CS Memorandum No. 1685

Subject: Configuration Management Board Meeting No. 166

CMB Meeting Minutes #166

SUBJECT: Configuration Management Board Meeting # 166 – Rev. No. 0

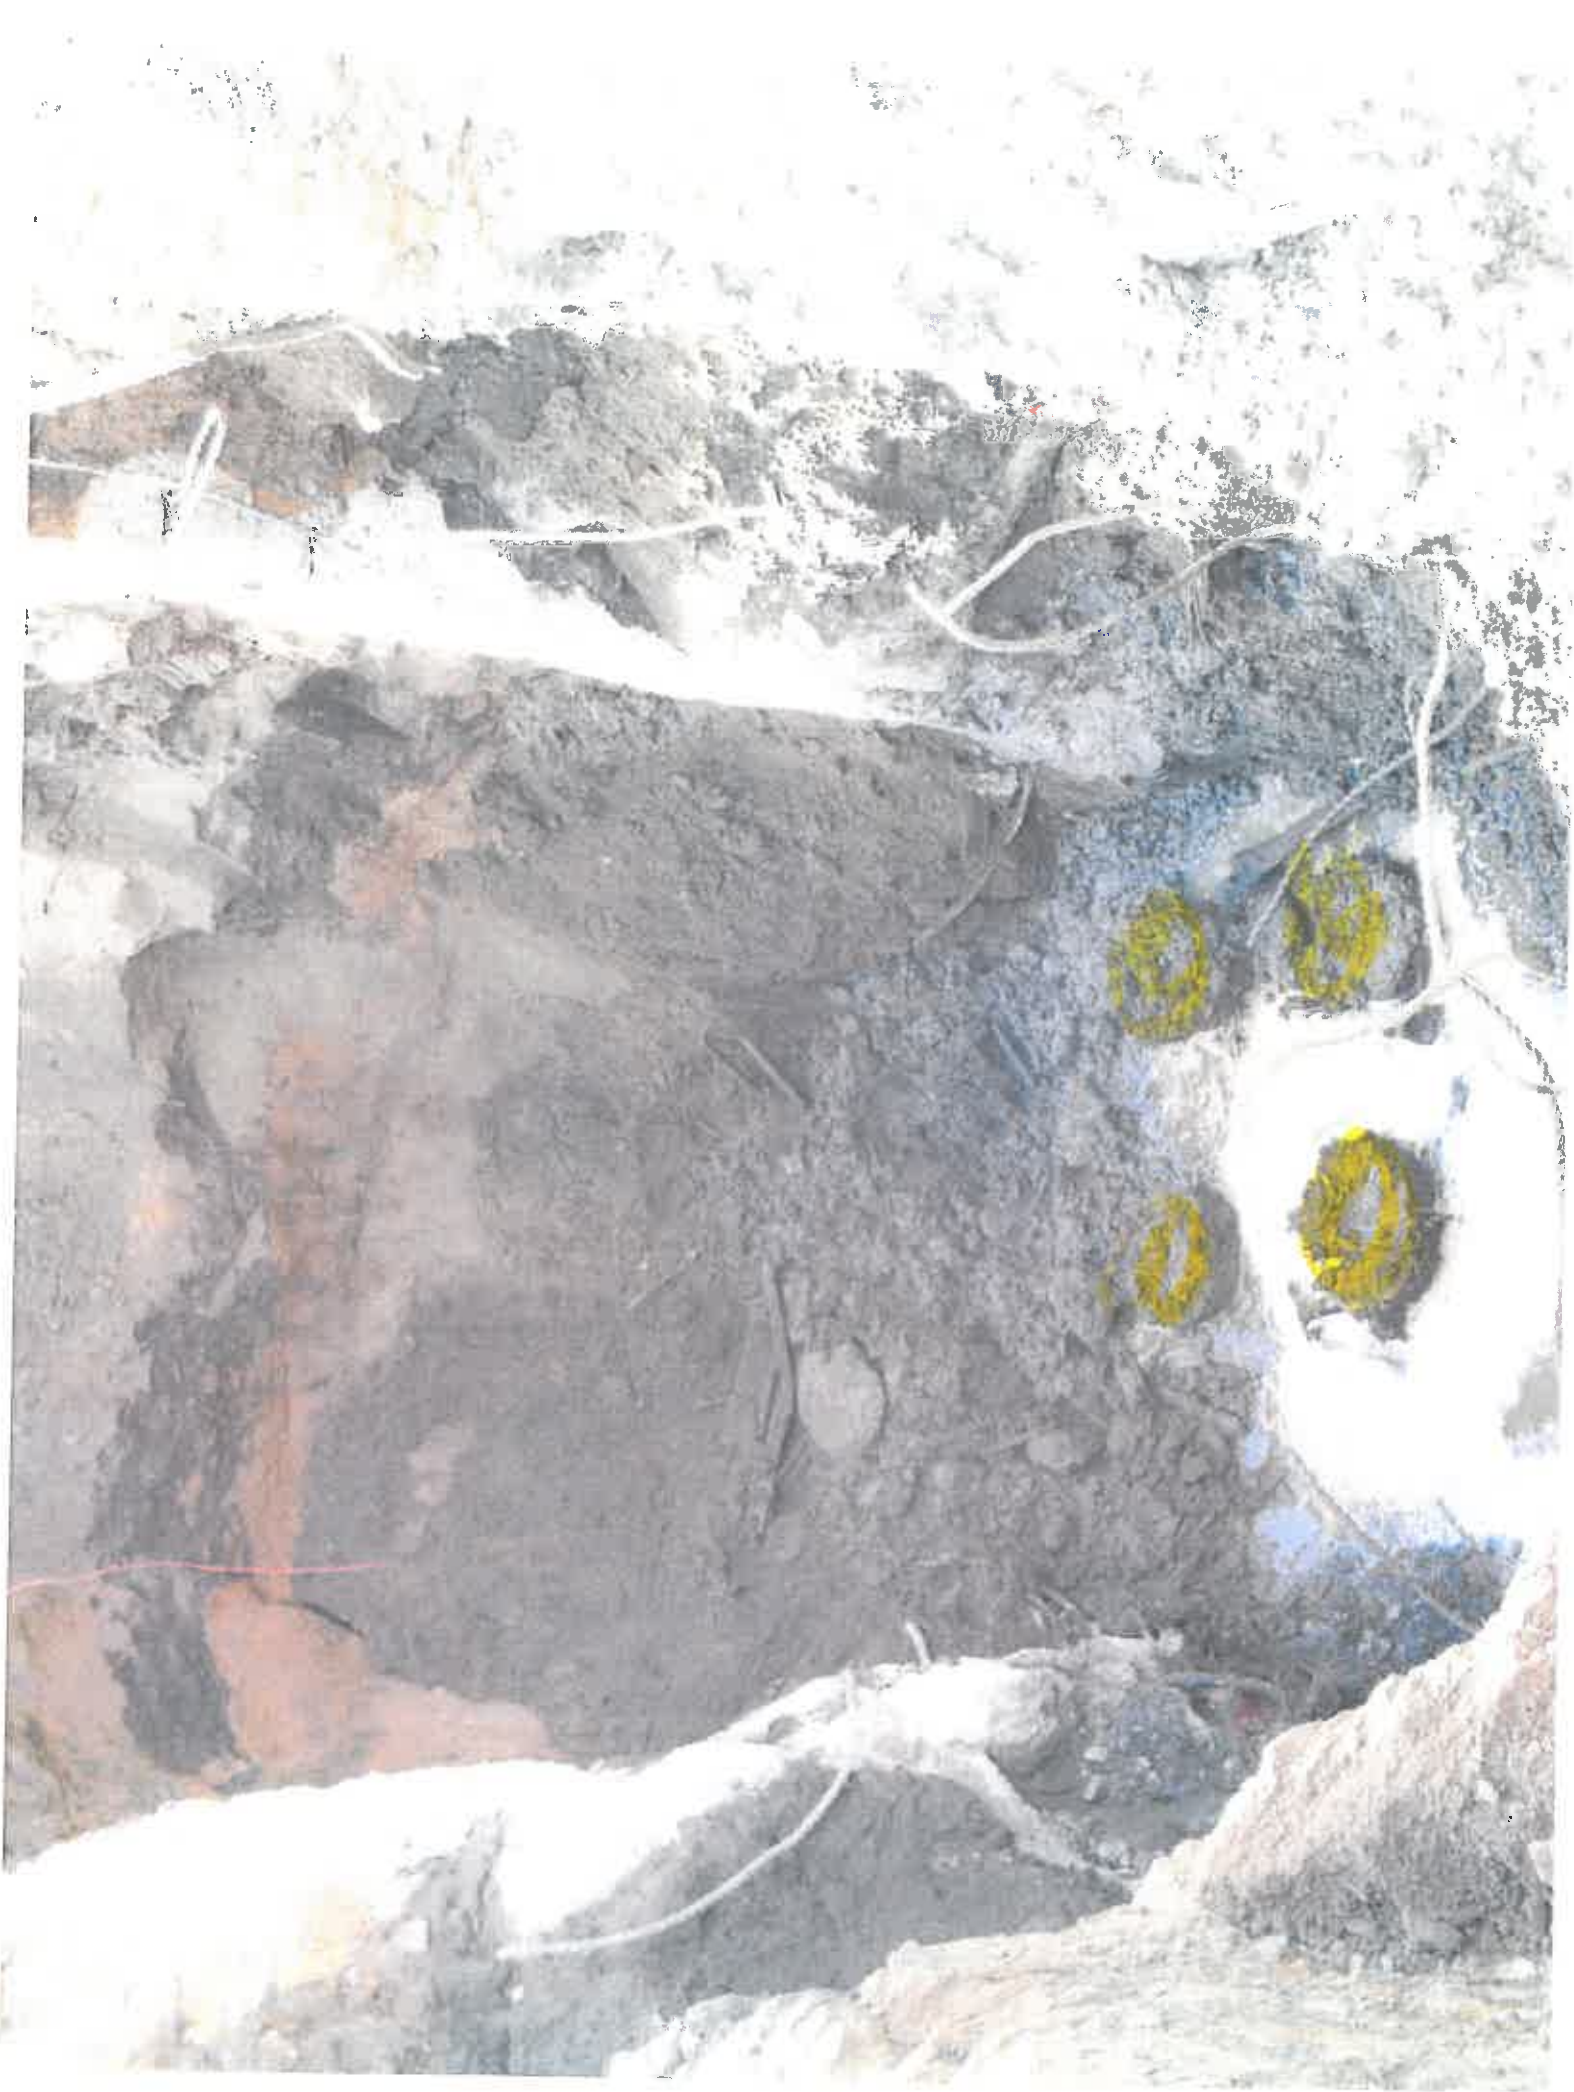
Pursuant to General Provisions 3.04, please see attached correspondence from Layne Christensen dated April 3, 2014 providing Notice of Differing Site Conditions for timber piles encountered in the slurry wall excavation.

- Location: H Line between Grid Lines 09 – 10
- Nature & Extent: Timber Piles in excavation footprint, depth assumed to be 40'-80'
- Conditions Affecting Work: Timber Piles are in conflict with excavation and must be removed in advance of slurry wall excavation
- Recommendations: SFMTA inspect the buried wood piles, issue a Force Account Change order authorizing the extraction of the buried wood piles with a HPSI Model 150 Vibratory Hammer with a Timber Clamp to minimize the effect of vibration.
- Baseline: The contract demolition plans that do not address these buried wood piles.
